IN THE DRAWINGS:

Please replace the two (2) drawing sheets containing Figs. 1B and 1C and Figs. 6, 7, 9 and 14 with the "Replacement Sheets" included herewith. The corrections are shown in red ink on the two (2) sheets labeled "Annotated Marked-Up Drawings" also included, and reflect the following addition and modifications:

REMARKS:

FIG. 1B

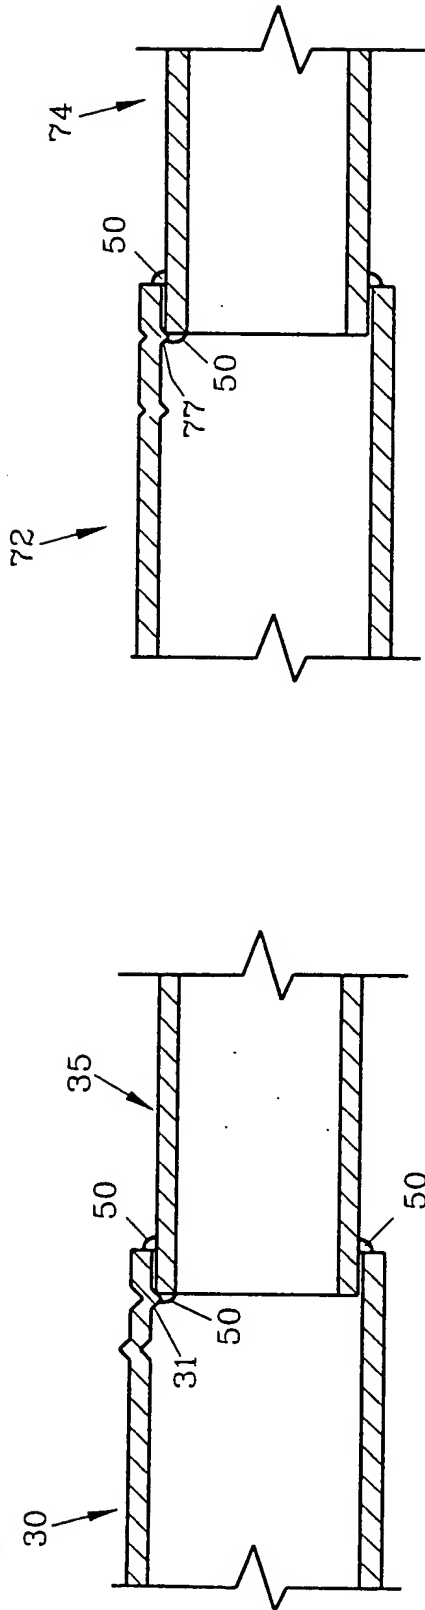
- 1) Numeral 18 in Fig. 1B to show threaded member 18;
- 2) In Fig. 7, numeral 39 has been changed to numeral 40, numeral 42 has been changed to numeral 39 and numerals 36 and 41 with their respective directional lines and arrows have been removed.
